**KERR-McGEE CORPORATION**

RE: License STA-583
Docket 40-2061

AMENDMENT REQUEST
KERR-McGEE CHEMICAL CORPORATION
WEST CHICAGO FACILITY
LICENSE STA-583, DOCKET 40-2061

FIGURE 1. ACCESS ROAD LOCATION

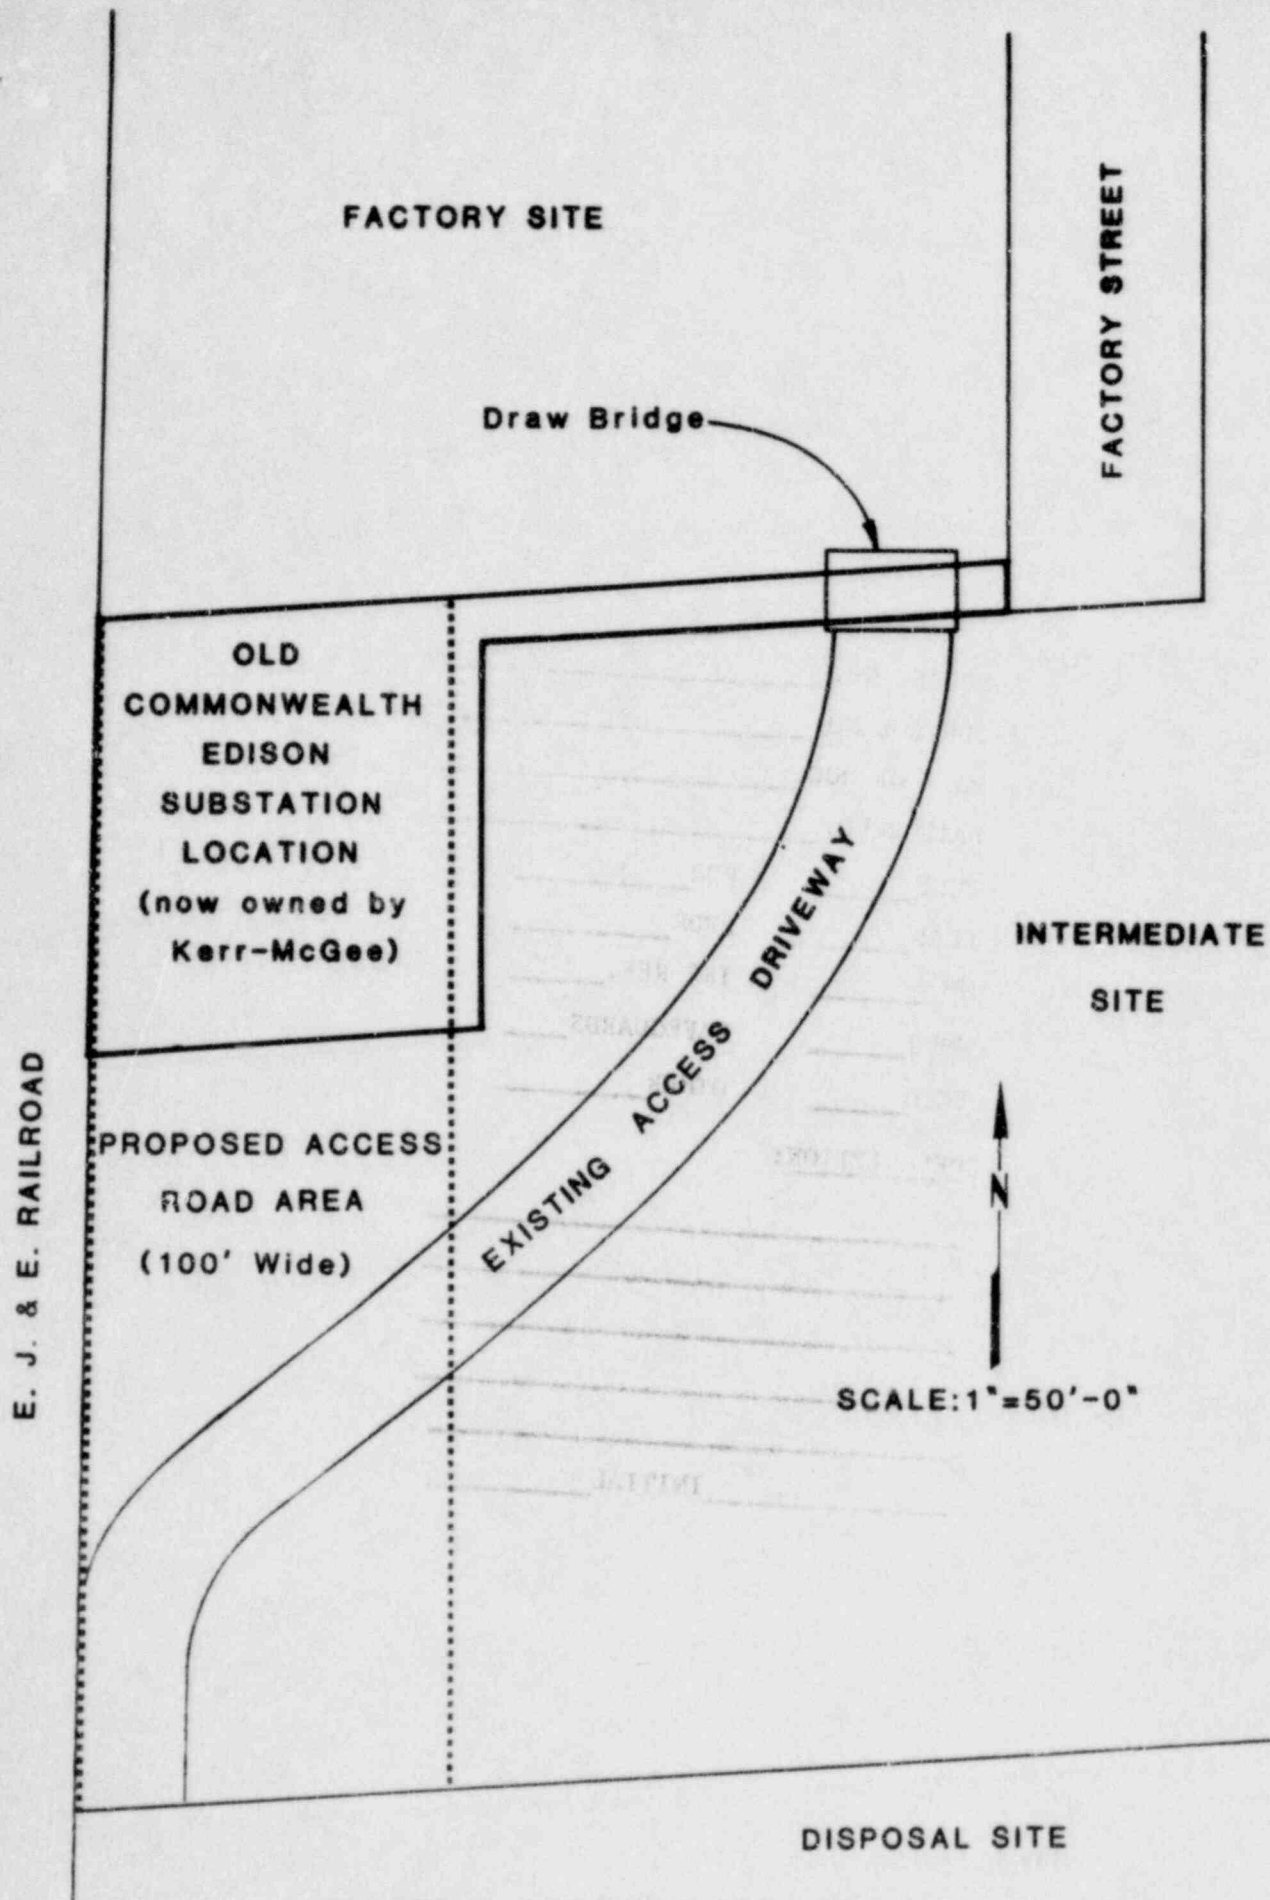
The location of the existing driveway and proposed access road between the Factory and Disposal Sites lies in the west portion of the Intermediate Site adjacent to the EJ&E right of way. (See Figure 1.) Kerr-McGee Chemical Corporation has recently acquired the tract of land previously owned by Commonwealth Edison. This property, identified on Figure 1, was the location of an electrical power substation. The substation is no longer in operation, and all equipment has been removed. Purchase of the property by Kerr-McGee now allows a straight and wider access between the Factory and Disposal Sites.

A drawbridge was installed several years ago to provide access across Commonwealth Edison property. This bridge is no longer required. The existing driveway between the Factory and Disposal Sites is restricted to one-way traffic and winds its way around the incineration system, which is located on the south end of the Factory Site. The proposed road will allow straight access, along the west side of the incinerator, and provide for safe two-way heavy construction equipment traffic, with unobstructed vision for the operators.

Kerr-McGee Chemical Corporation plans to use on-site demolition materials (bricks and concrete rubble) to construct a new roadway which will provide adequate access between the Factory and Disposal Sites. The old Commonwealth Edison property and an area near the northwest corner of the Disposal Site will require significant fill material to bring the road surface to the proper elevation. Building rubble generated from the Factory Site demolition activities will be used for filling these areas and provide a stable road base.
